FOUNDATION LUTHERAN CHURCH

DEVELOPMENT PLAN COVER SHEET

FINAL LANDSCAPE PLAN

1 ARCHITECTURAL SITE PLAN

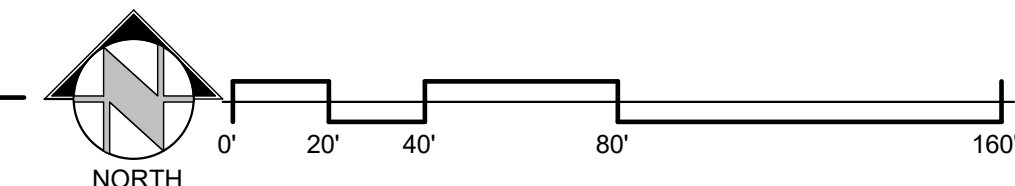
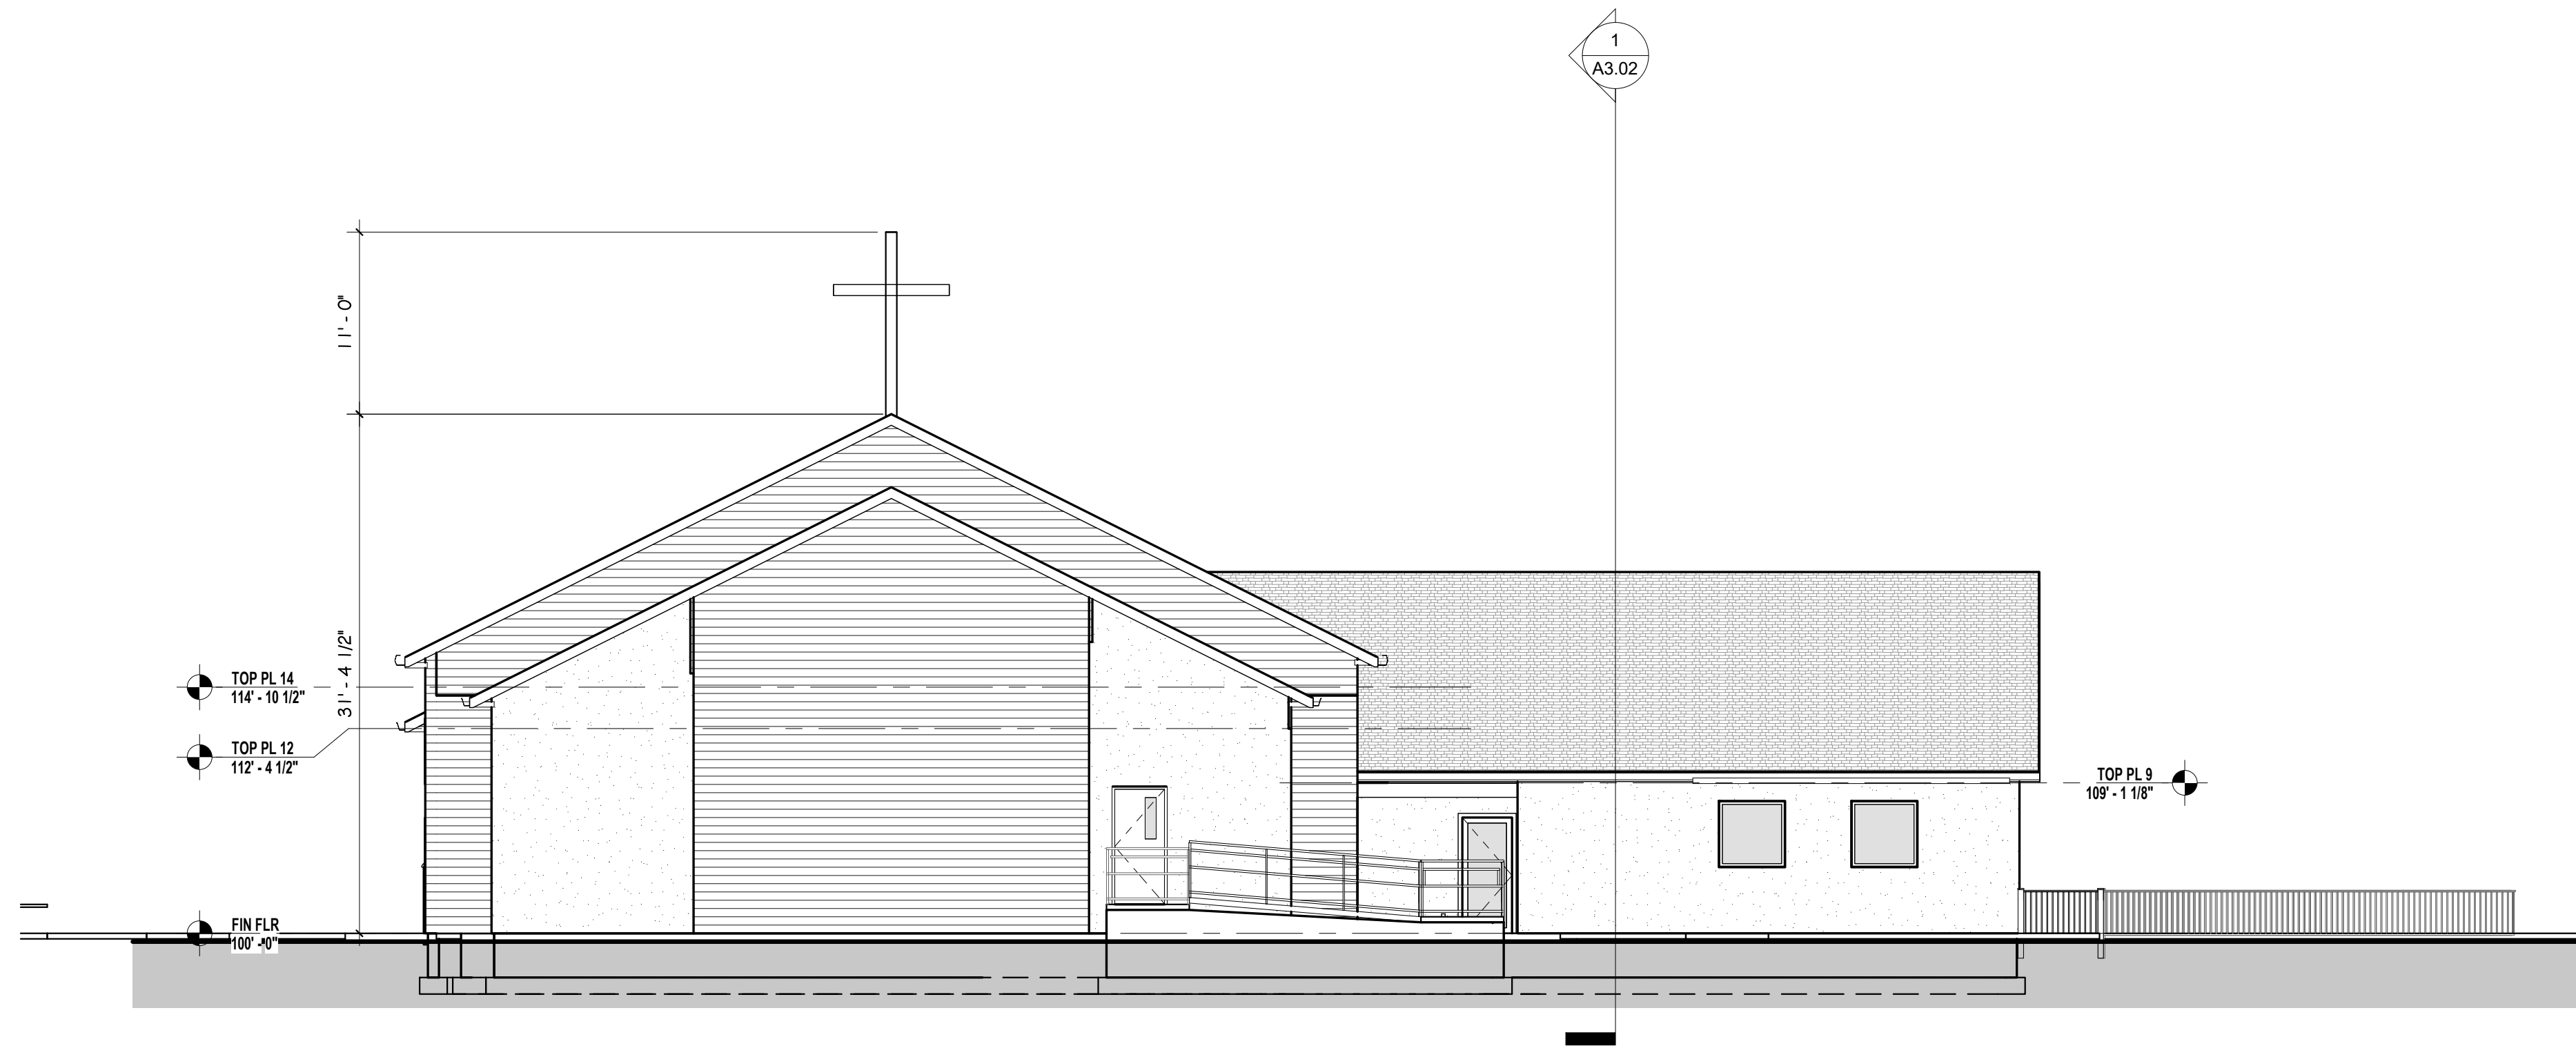
Add "PCD File No. PPR2321"

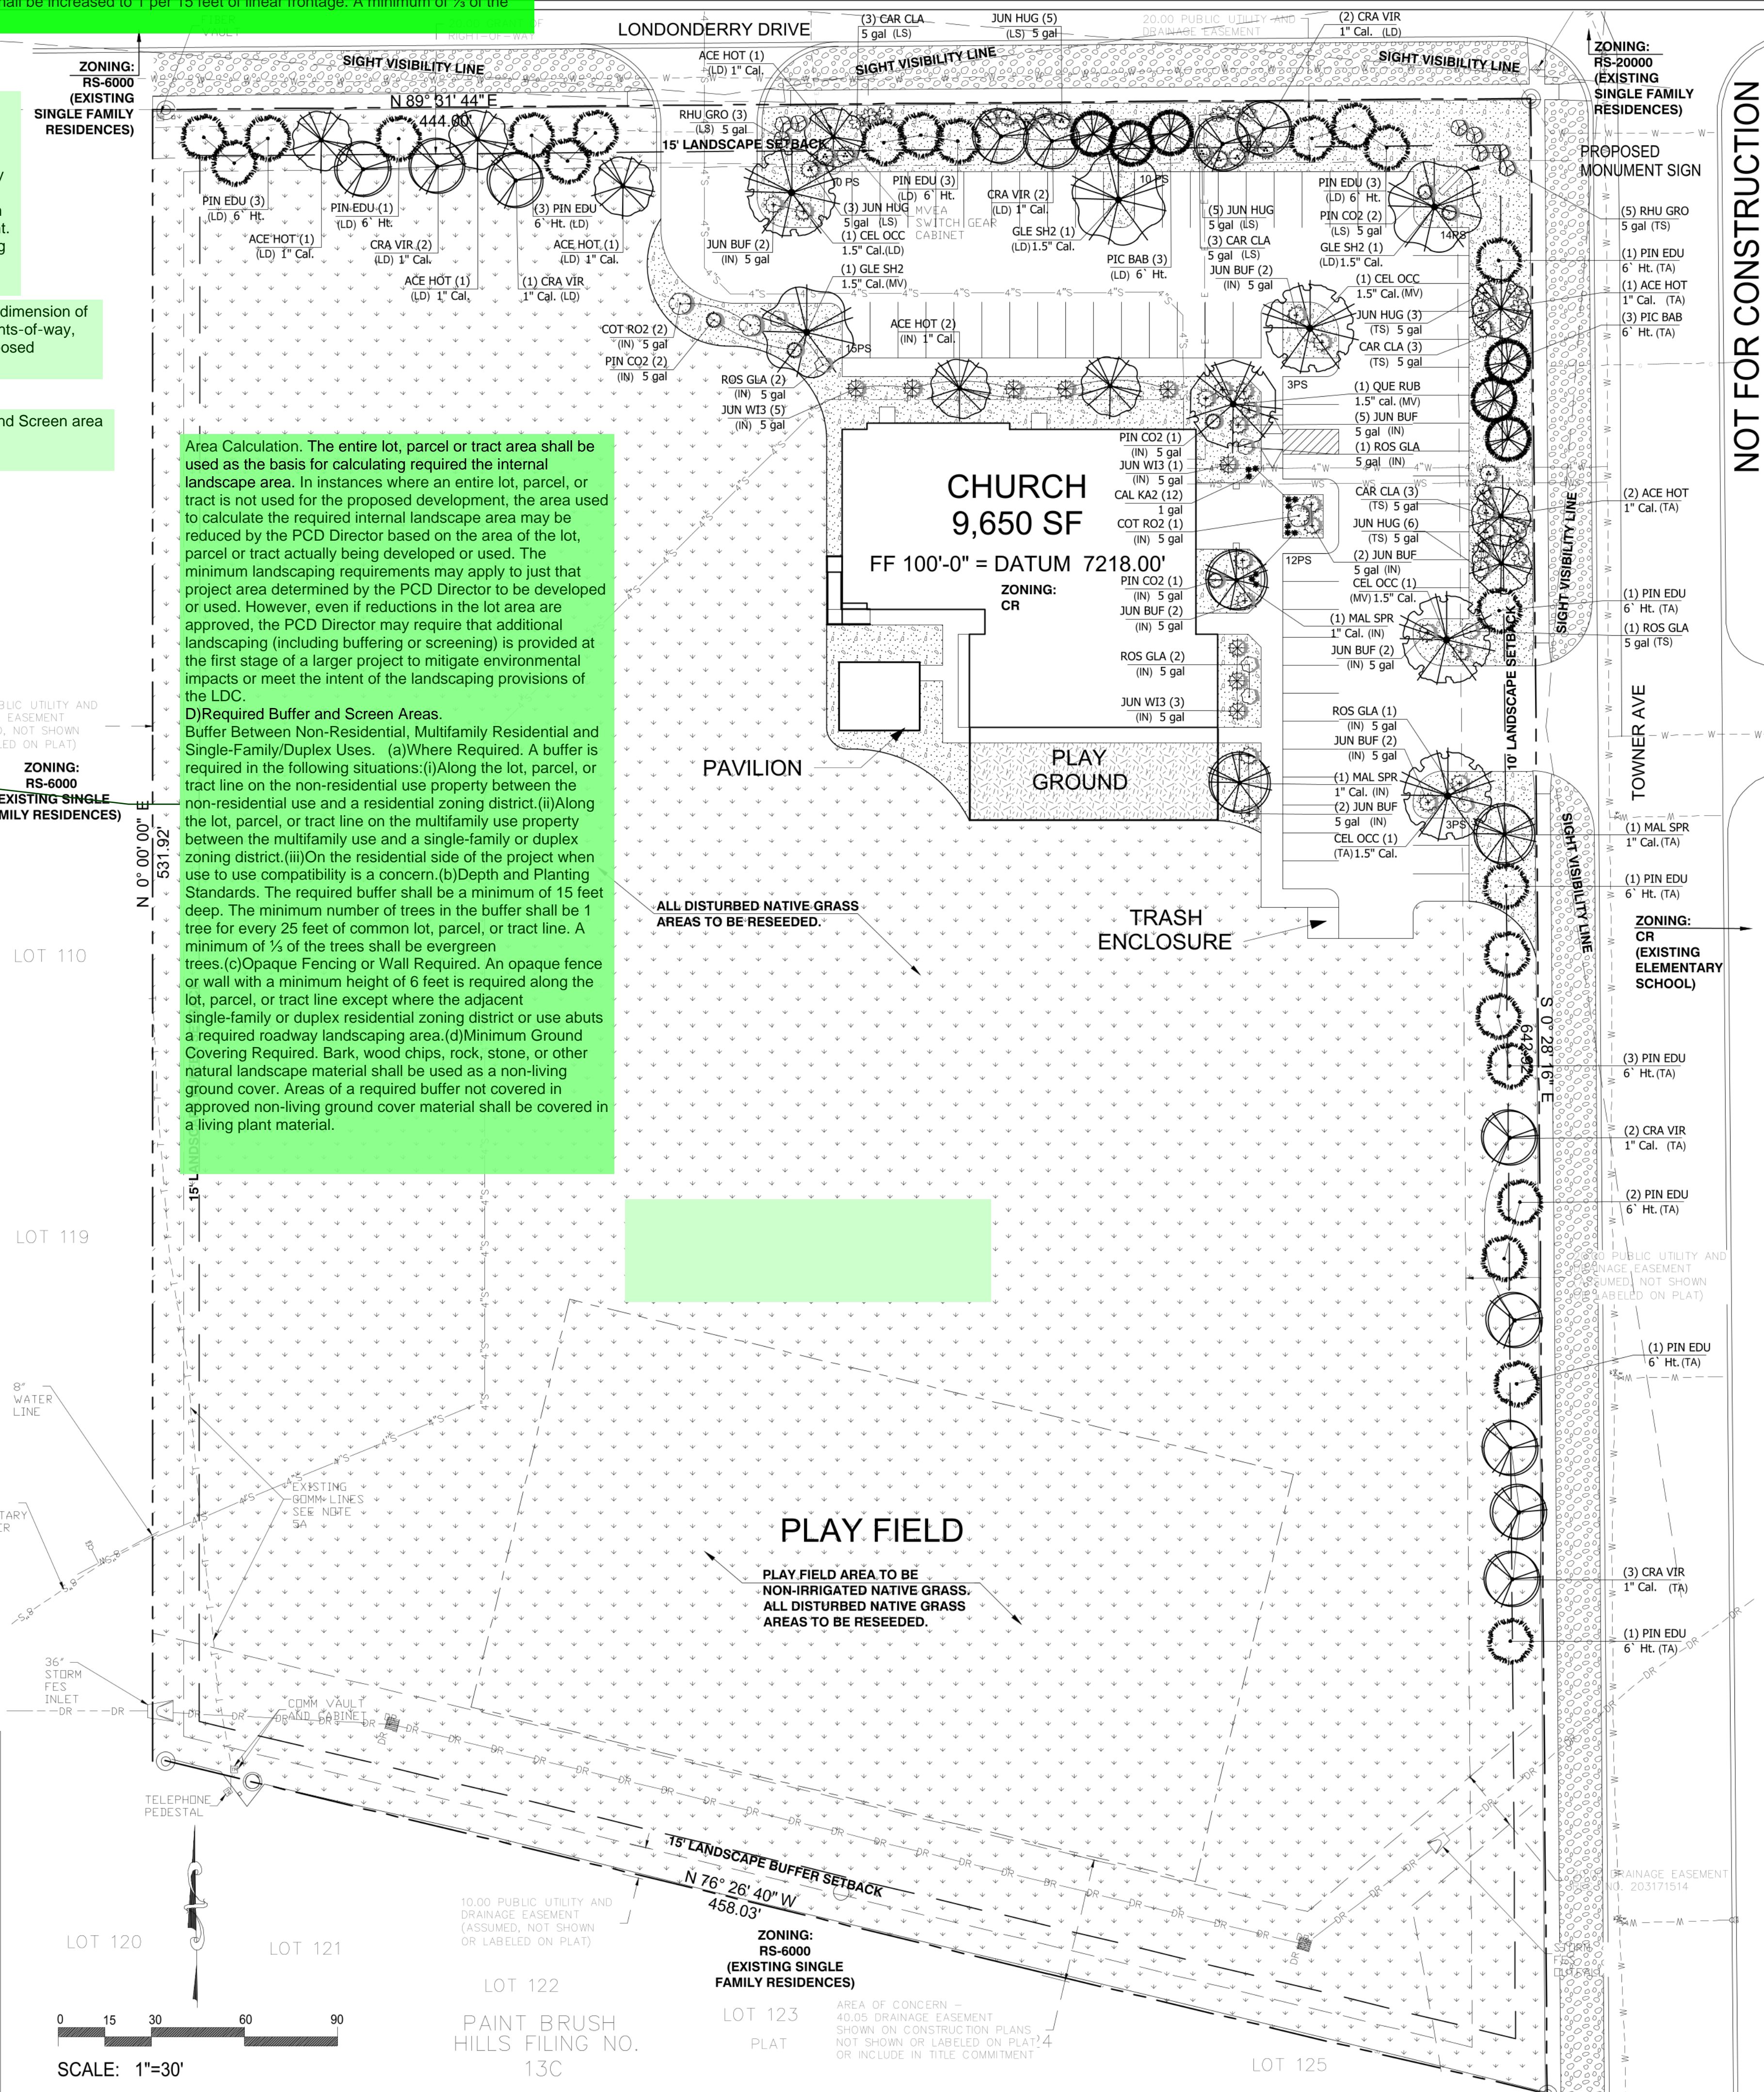
Unless otherwise approved by the ECM Administrator, the depth of roadway landscaping shall be measured from the property line. Where a roadway easement has been provided, the measurement shall be from the ROW or roadway easement. In reference to the landscaping Located on Londonderry Drive and Towner Ave

Identify all Location and dimension of the all property lines, rights-of-way, and all existing and proposed easements.

You will need to provide the required Buffer and Screen area around the Western and Southern Boundary.

Area Calculation. The entire lot, parcel or tract area shall be used as the basis for calculating required the internal landscape area. In instances where an entire lot, parcel, or tract is not used for the proposed development, the area used to calculate the required internal landscape area may be reduced by the PCD Director based on the area of the lot, parcel or tract actually being developed or used. The minimum landscaping requirements may apply to just that project area determined by the PCD Director to be developed or used. However, even if reductions in the lot area are approved, the PCD Director may require that additional landscaping (including buffering or screening) is provided at the first stage of a larger project to mitigate environmental impacts or meet the intent of the landscaping provisions of the LDC.

D)Required Buffer and Screen Areas. Buffer Between Non-Residential, Multifamily Residential and Single-Family/Duplex Uses. (a)Where Required. A buffer is required in the following situations:(i)Along the lot, parcel, or tract line on the non-residential use property between the non-residential use and a residential zoning district.(ii)Along the lot, parcel, or tract line on the multifamily use property between the multifamily use and a single-family or duplex zoning district.(iii)On the residential side of the project when use to use compatibility is a concern.(b)Depth and Planting Standards. The required buffer shall be a minimum of 15 feet deep. The minimum number of trees in the buffer shall be 1 tree for every 25 feet of common lot, parcel, or tract line. A minimum of 1/2 of the trees shall be evergreen trees.(c)Opaque Fencing or Wall Required. An opaque fence or wall with a minimum height of 6 feet is required along the lot, parcel, or tract line except where the adjacent single-family or duplex residential zoning district or use abuts a required roadway landscaping area.(d)Minimum Ground Covering Required. Bark, wood chips, rock, stone, or other natural landscape material shall be used as a non-living ground cover. Areas of a required buffer not covered in approved non-living ground cover material shall be covered in a living plant material.
